STAFF RECOMMENDATION
700 Monroe Street
April 17, 2013

Application: Signage; Setback Reduction
District: Germantown Historic Preservation Zoning Overlay
Council District: 19
Map and Parcel Number: 08209001000
Applicant: Carl Bell, A-1 Signs
Project Lead: Melissa Baldock, melissa.baldock@nashville.gov

D/F ILLUMINATED MONUMENT SIGN

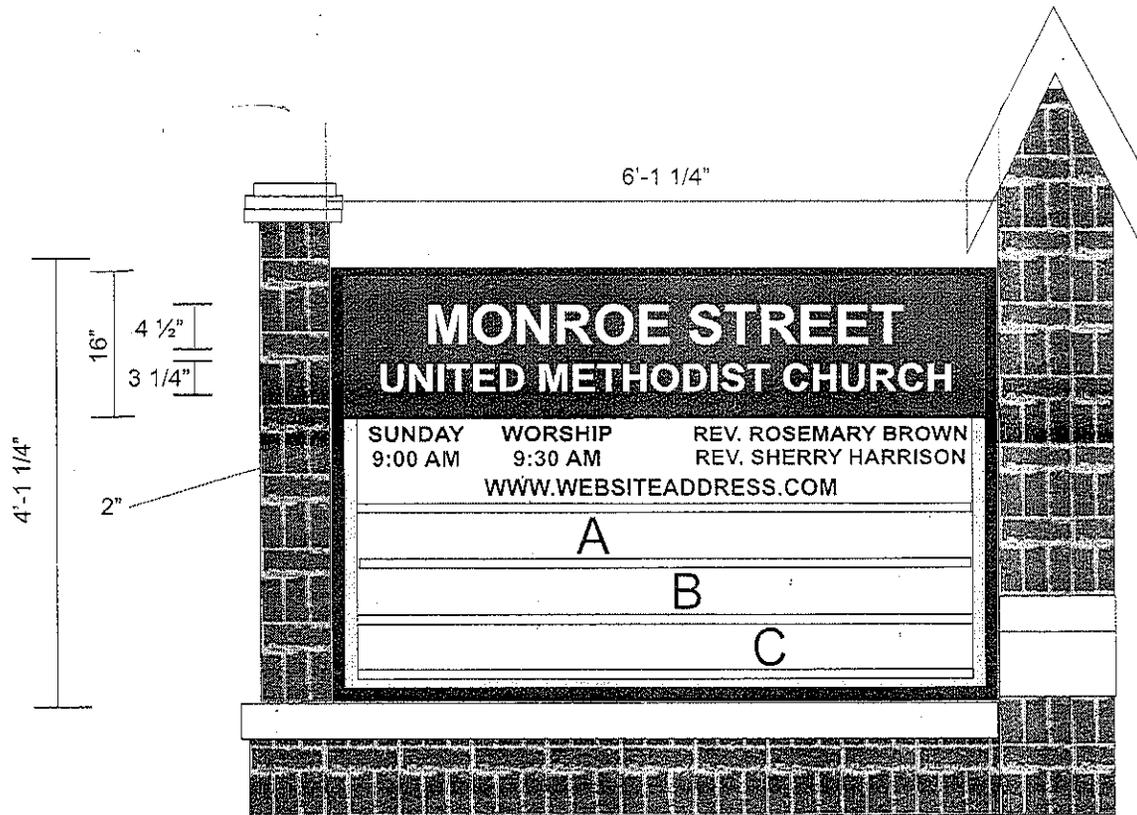
Design & Materials: The design guidelines state that that “Monument signs shall be limited to a height of 6’, a thickness of 12”, and a total area of 16’.” In this case, the sign itself is six feet, one inch (6’1”) wide and four feet, one inch (4’1”) tall. The area will therefore be more than twenty four square feet (24 sq. ft.). Staff asks the applicant to reduce the size of the signage so that it is sixteen square feet (16 sq. ft.) or less. The sign cabinet is one foot (1’) deep, which is appropriate. The sign will be mounted on a brick

base. The dimensions of the brick base were not provided on the drawings, and the drawings submitted are not to scale. Staff asks that a condition of approval be that new drawings that are to scale be provided. Staff also asks to approve a brick sample.

The material of the sign face will be panformed lexan polycarbonate with flat painted copy. The bottom section of the sign will have three lines of track for four inch (4") changeable copy, which is appropriate.

The sign is proposed to be internally illuminated with fluorescent lamps. Internal illumination does not meet the design guidelines. Staff asks that a condition of approval be that the sign not be internally lit and that staff approve any plans for external illumination.

1. The applicant submit new drawings that are to scale.
2. The sign be reduced to be sixteen square feet or less.
3. Staff review and approve a brick sample prior to purchase and installation.
4. The sign not be internally illuminated and the applicant submit information any external illumination.
